SIB (Service Information Bulletin)

Model	K4 2017 series
Revision	Revision 1.0
Date	27th Jul 2017

No Power on Guide

Model	K4 2017 series	Revision	Rev 1.0	Date	27 th Jul 2017	Country	Global	Buyer	All	Type	H/W
Contents	☒ Service Information ☐ Guide ☐ Notification					Target	☒ BRC ☐ DSC ☐ ASC ☐ CIC

<Test Point of K4 2017 series>

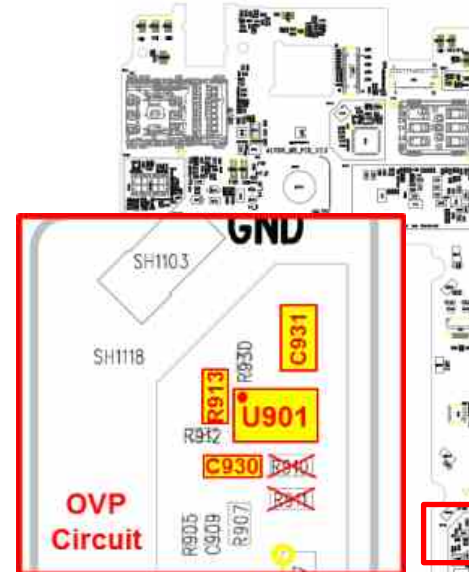
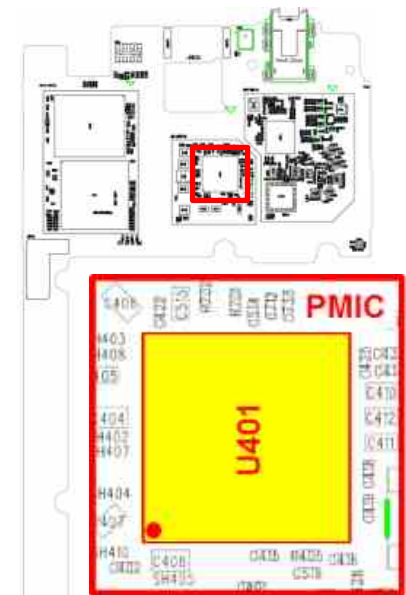
- If Phone is No Power-on (overcurrent),
should add OVP circuit and replace with new PMIC.

Location no	As-is	To-be
U901	DNI	EAN64971401 (IC, OVP)
C930	DNI	EAE65046201 (Capacitor)
C931	DNI	EAE64621606 (Capacitor)
R913	DNI	EBC64155608 (Resistor)
R910 / R910	EBC64155605	Remove

※ PMIC P/N : EAN63748001
(Location no : U401)
